# **ACE/ATRIUM 11 Critical Power Correlation - RAIs**

ANP-10335Q1NP  
Revision 0

## Topical Report

A boiling water reactor ACE/ATRIUM™\* 11 critical power correlation topical report is provided in Reference 2. This document provides responses to a Request for Additional Information (RAI) (Reference 1) on that topical report.

Figure 1. KATHY Thermal-hydraulic Test Loop

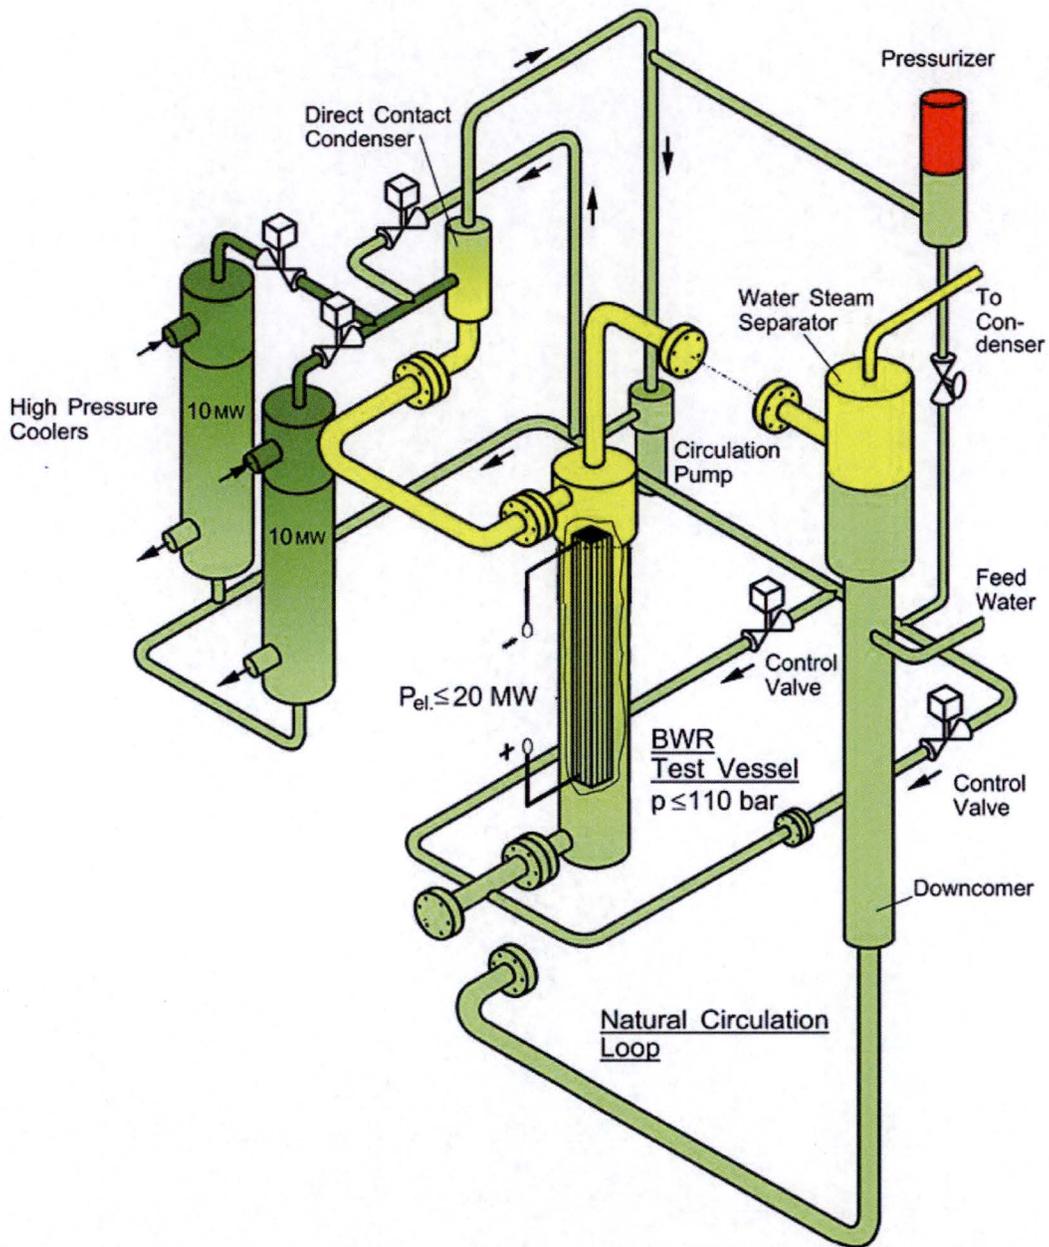
*Please provide references to documents describing the test loop and facility in greater detail, as well as the quality assurance program to be applied.*

All of the data for the ACE/ATRIUM 11 critical power correlation were taken at the AREVA KATHY thermal-hydraulic test loop located in Karlstein, Germany. Figure 1 shows that the thermal hydraulic test facility is a high pressure water heat transfer loop containing a test vessel (shown in Figure 2) with the test assembly and upper and lower bus bars, high pressure coolers, a direct contact condenser, an electrically heated pressurizer, and the main circulation pumps. Two inlet flow lines of different sizes are shown. The different sizes allow fine control of the flow rate over a broad range. The test loop is rated at [ ] The DC power supply consists of four thyristor controlled rectifiers, providing a total electrical current of [ ]
